ADDENDUM NO. 1
OSBORNE PARK WALKING PATH AND PARKING LOT IMPROVEMENT
CITY OF WILLOUGHBY, LAKE COUNTY, OHIO
ISSUED JULY 6, 2016
BY LDC, INC., William C. Vondra, Jr., P.E., P.S.

CITY OF WILLOUGHBY
BID PROPOSAL FORM
 OSBORNE PARK WALKING PATH AND PARKING
 Sheet 1 of 4

PARKING GATE
 NO SCALE

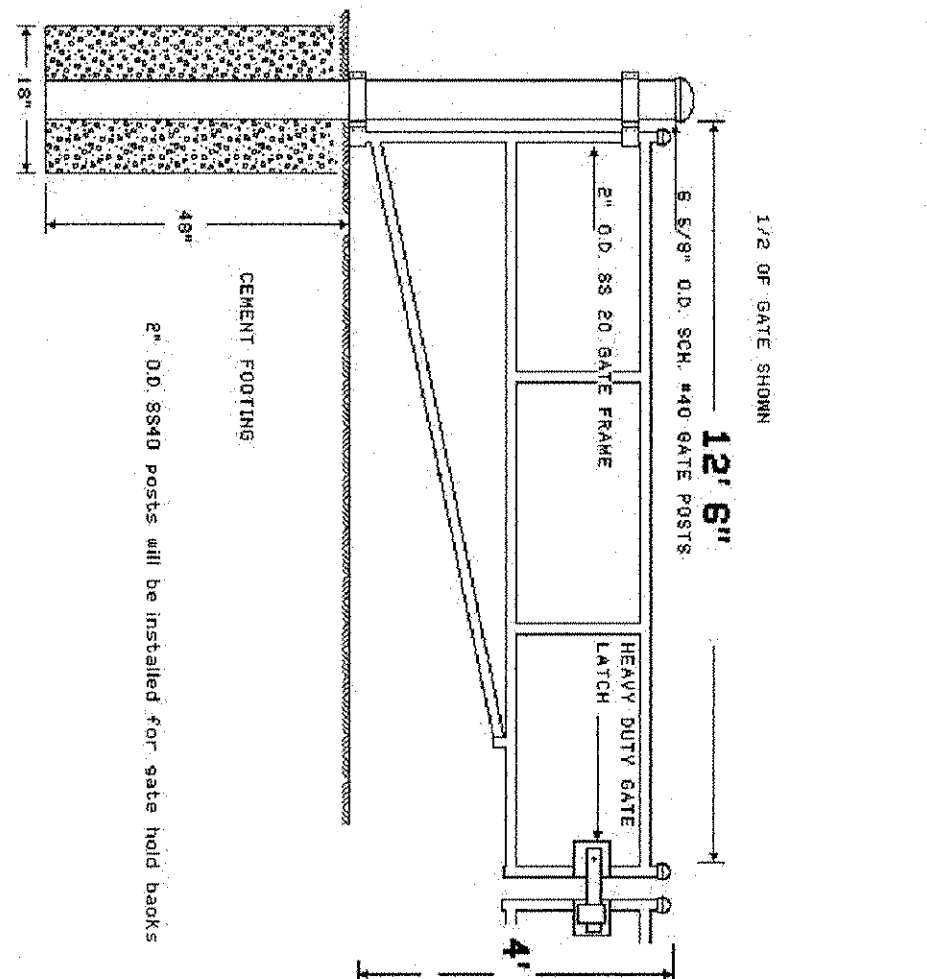
- 2) Plan sheet 10/10. A detail illustrating half of the Parking Gate (Bid Item M-6) has been added to the sheet.

PART OF ADENDUM 1
 7/5/2016 - ADDED PARKING GATE DETAIL
